Value Engineering Study Report

US 641 Connect Eddyville to Fredonia
Kentucky Transportation Cabinet (KYTC)
Item #1-187.31

Caldwell and Lyon Counties, Kentucky

Structure #3 - Recommendation

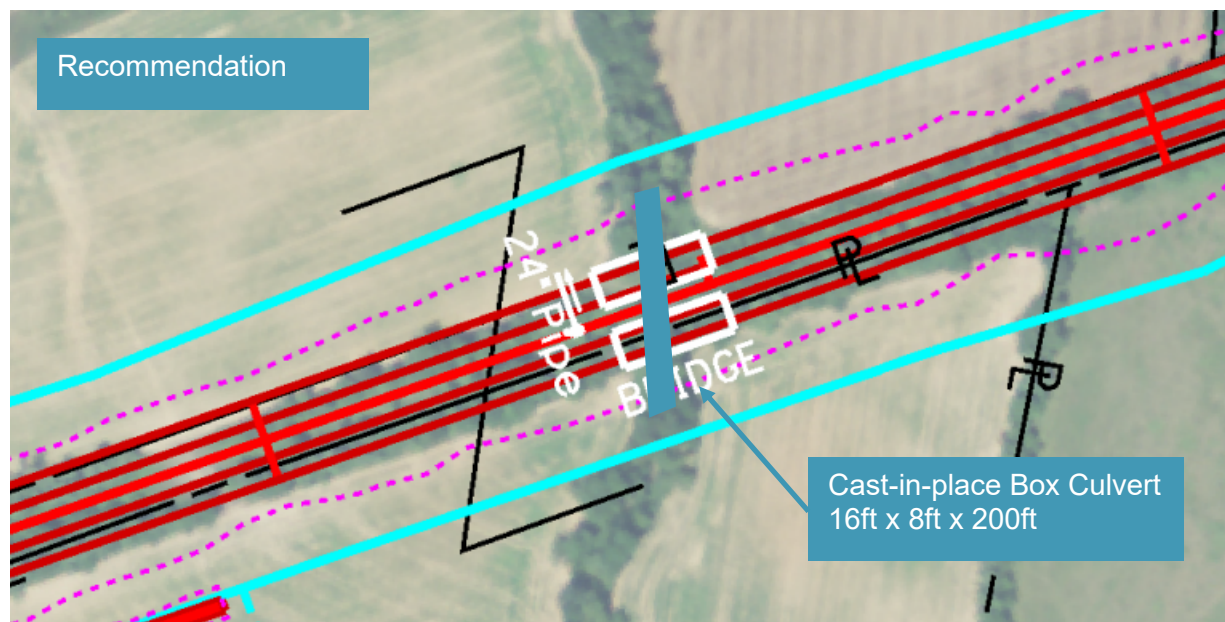
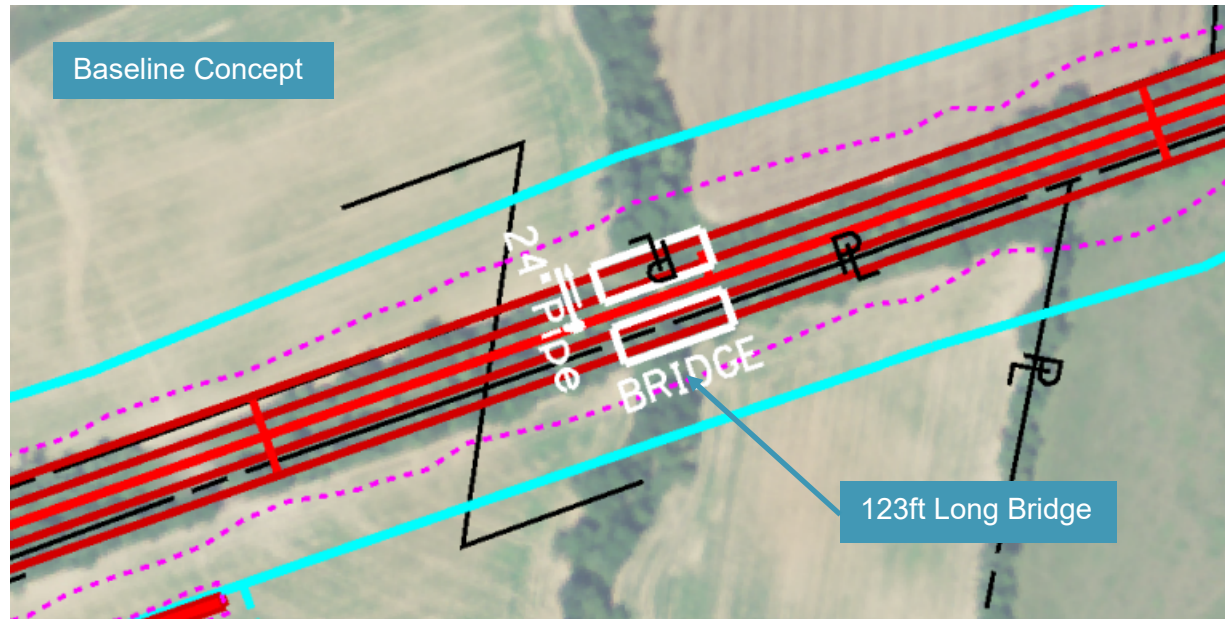
Total Cost		Structure #1				
\$ 896,000		16ft x 8ft x 180ft	25600	Cu ft	\$ 35	\$ 896,000
\$ 2,335,360						
\$ 896,000		Structure #3				
<u>\$ 2,571,520</u>		16ft x 8ft x 180ft	25600	Cu ft	\$ 35	\$ 896,000
\$ 6,698,880						
		Elimination of Channel Change				
		Could decrease construction cost by approximately \$400,000-\$500,000 total for earthwork, in-lieu fees and permitting.

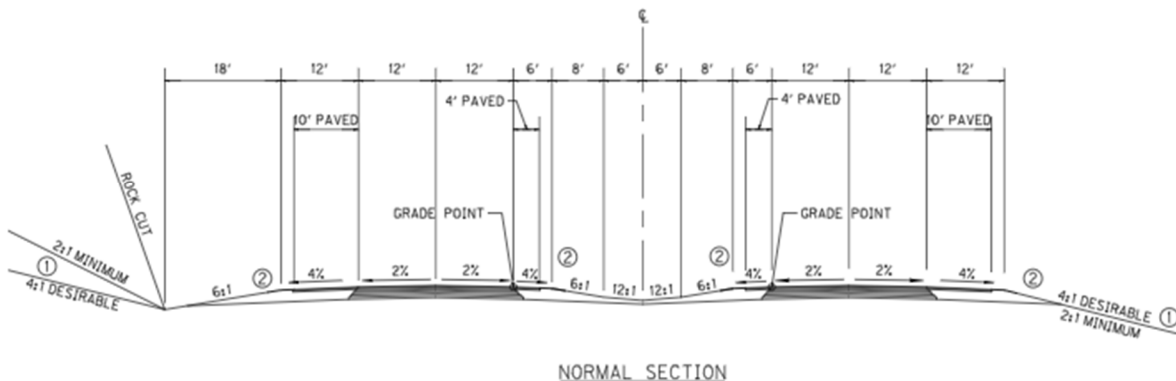
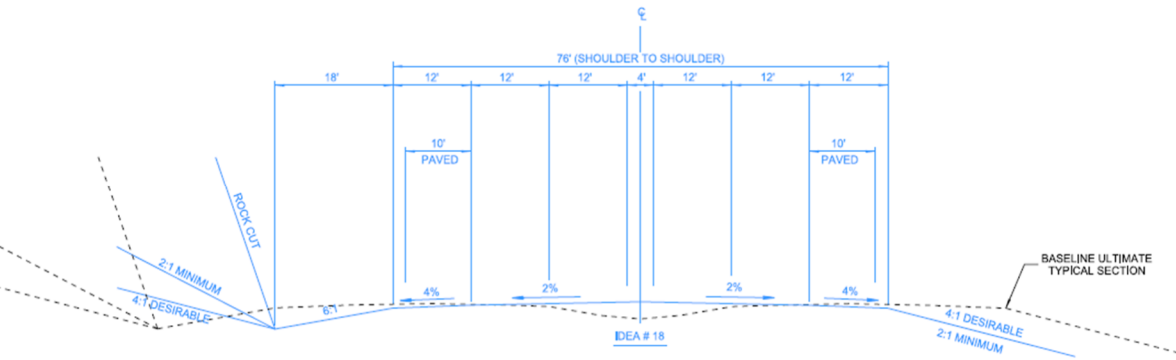
VE RECOMMENDATION NO. 5: ALTERNATIVE 4-LANE TYPICAL SECTION		Idea Nos. 18, 22, 28		
Baseline Concept				
The proposed preferred typical section includes four 12' lanes, 12' outside shoulders, and a 40' depressed median which includes 6' inside shoulders.				
Recommendation Concept				
The VE team looked at three options for changing the typical section in regard to the ultimate configuration of the project. The team's recommended alternative eliminates the 40' depressed median and replaces it with a 4' paved median, while maintaining the rest of the original typical section.				
Advantages		Disadvantages		
<ul style="list-style-type: none">• Requires less right-of-way acquisition• Improves stormwater drainage• Reduces embankment• Reduces construction cost		<ul style="list-style-type: none">• Potential for more vehicle crossovers leading to head-on or sideswipe crashes• Access management strategies limited

<p>VE RECOMMENDATION NO. 5: ALTERNATIVE 4-LANE TYPICAL SECTION</p>	<p>Idea Nos. 18, 22, 28</p>
<p>Discussion/Sketches/Photos/Calculations</p>	
<p>Technical Discussion/Sketches</p> <p>The primary functions of the US 641 project are to improve the existing roadway (safety and capacity) and improve freight mobility between I-24 and Marion (providing a route on the National Truck Network).</p> <p>The VE team looked at three options to be able to achieve the primary functions of the project. Those three options were:</p> <ol style="list-style-type: none"> Eliminate the 40' depressed median and replace it with a 4' paved median, while also maintaining the rest of the original Typical Section. Reduce outside paved shoulder width from 10' to 4'. This would leave a 2' gravel shoulder in addition to the 4' paved for a total outside shoulder width of 6' vs. the 12' in the typical section. Use the Alabama 55 cross section (four 12' lanes, 2' paved outside shoulders, 4' median). <p>Ultimately, the VE Team recommendation is Option A.</p> <p>The Preferred Typical Section is the following:</p>  <p>The VE team is recommending eliminating the 40' depressed median and replacing it with a 4' paved median. The following is the recommended typical section:</p>

VE RECOMMENDATION NO. 6: ALTERNATIVE 2+1 TYPICAL SECTION

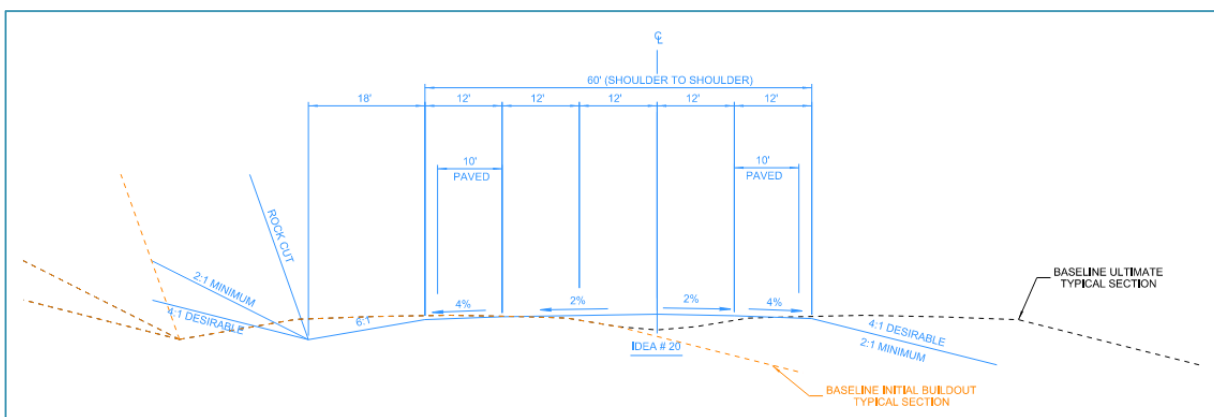
VE RECOMMENDATION NO. 6: ALTERNATIVE 2+1 TYPICAL SECTION		Idea Nos. 20, 23, 24, 27, 31		
Baseline Concept				
The proposed Typical Section includes four 12' lanes, 12' outside shoulders, and a 40' depressed median which includes 6' inside shoulders for the length of the new route.				
Recommendation Concept				
Change the Typical Section from what is proposed to a 2+1 for the length of the new route. The 2+1 would have two 12' lanes with an alternating 12' passing lane and 12' outside shoulders.				
Advantages		Disadvantages		
<ul style="list-style-type: none">• Requires less R/W acquisition• Improves stormwater drainage• Reduces embankment• Reduces construction cost• Allows for expansion to future 4-lane typical		<ul style="list-style-type: none">• Potential County stakeholder acceptance		
Cost Summary		Construction	Right-of-Way	Total
Baseline Concept		\$62.98M	\$1.57M	\$64.55M
Recommendation Concept		\$43.14M	\$1.06M	\$44.20M

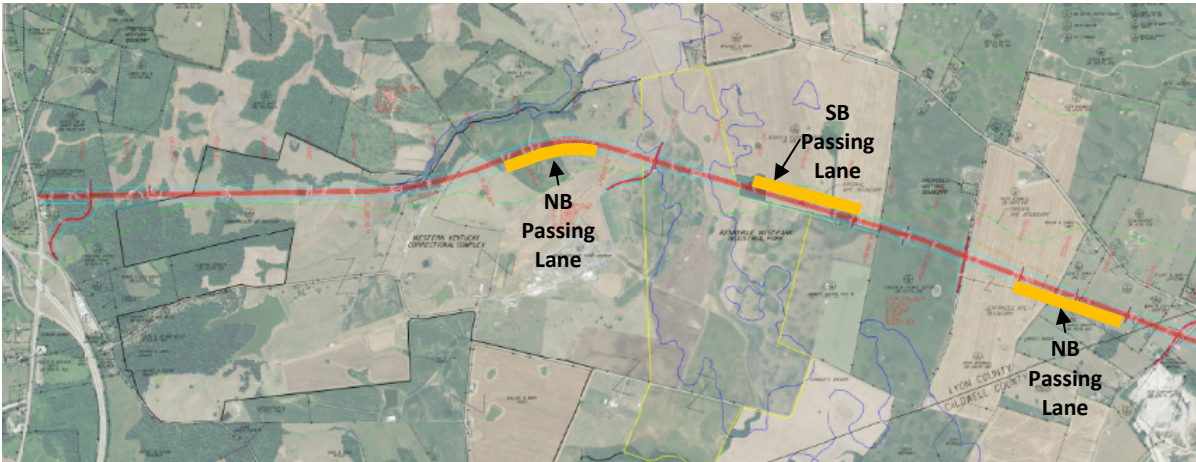
The typical section for the 2+1 corridor is shown below. This typical would consist of two 12' travel lanes, an alternating passing lane (12'), and 12' outside shoulders (10' paved, 2' gravel) on each side of the roadway. The total pavement width in passing sections would be 56'. Through sections without a passing lane would have a total pavement width of 42'.

The preferred alignment could be utilized for the 2+1 configuration accounting for 4 passing lanes (2 in each direction) throughout the project area. Based on KYTC guidance, passing lanes for roadways with this volume should be between 0.5 to 0.75mi in length. Assuming the appropriate taper lengths and approximately 0.5mi of passing lane length, it is feasible to accommodate the passing lanes while avoiding the bridges and having the passing lanes at intersections.

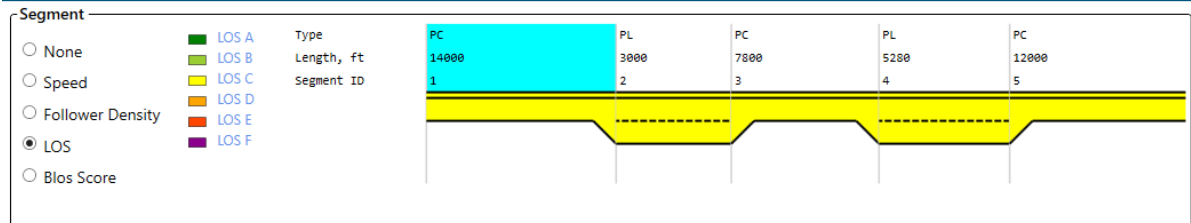
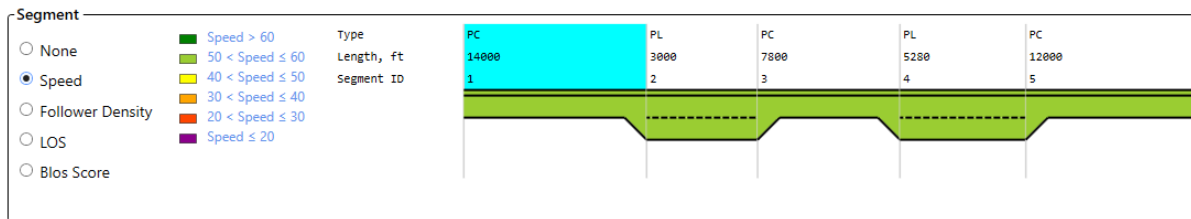
HCS7 Two-Lane Highways module was used to analyze the operations for the 2+1 configuration. Assumptions from the revised volume projections were used to determine DHV volumes. *It should be noted that the revised traffic projections are likely conservative when comparing to historic growth trends for this roadway and similar facilities.* A K factor of 10% was used to derive the volumes, and it was assumed that the directional split would be even 50/50. The volumes used for analysis range from 550 to 730vph. The truck percentages ranging from 25%-34% were used throughout the corridor. Based on those assumptions it is anticipated that the 2+1 configuration will operate with adequate speeds (>50mph) and adequate LOS (LOS C) through the 2040 design year. The analysis was based on peak volumes which are likely to occur one-hour per day, the remaining hours of the day will operate better than the LOS C conditions. The images below show the results of the DHV analysis for NB and SB.
